ST. TAMMANY PARISH

Addendum No.: 1

Bid#: 26-40-2

Project Name: Nolan Rd Ph 2

PIPE INSTALLATION DETAIL

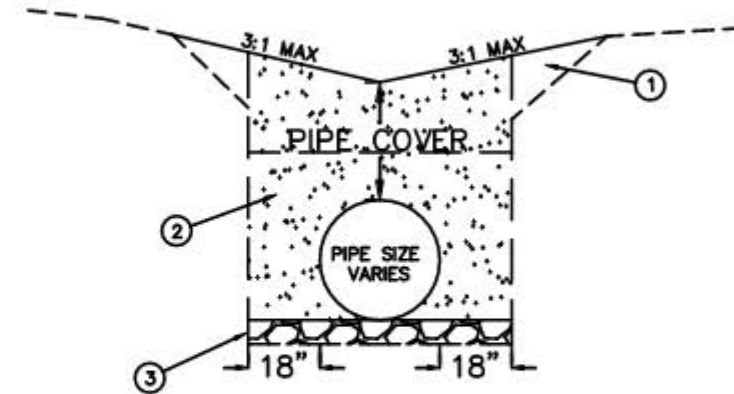
- Question 9.** Are we allowed to use excavated material as embankment?
- Answer 9.** Yes, as long as it does not interfere with compacted pipe backfill. Please refer to General Information #1.

SEWER EFFLUENT PIPE TIE-IN

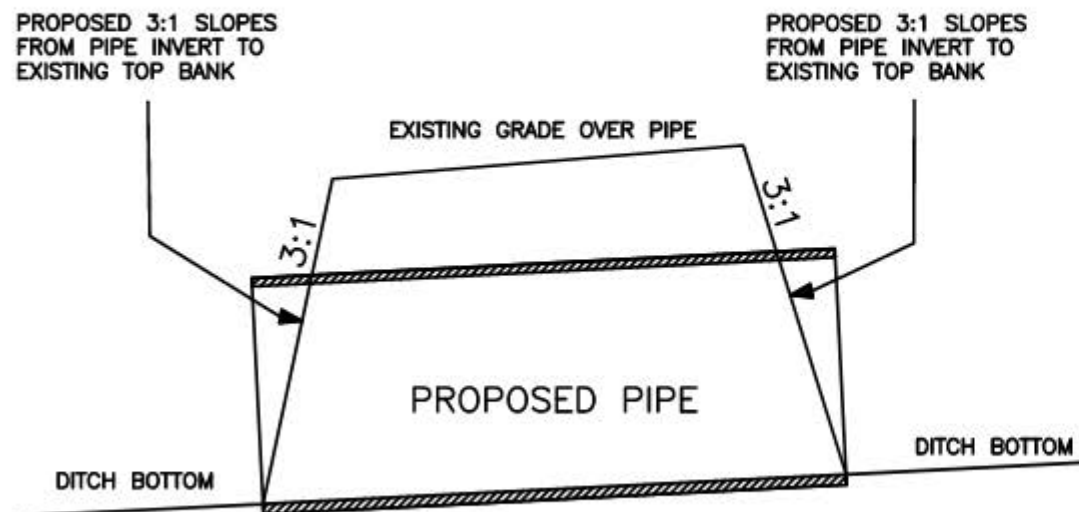
- Question 8.** Can you provide a detail for the required sewer tie ins? Also, which item will that be paid in?
- Answer 8.** Please refer to General Information #1.
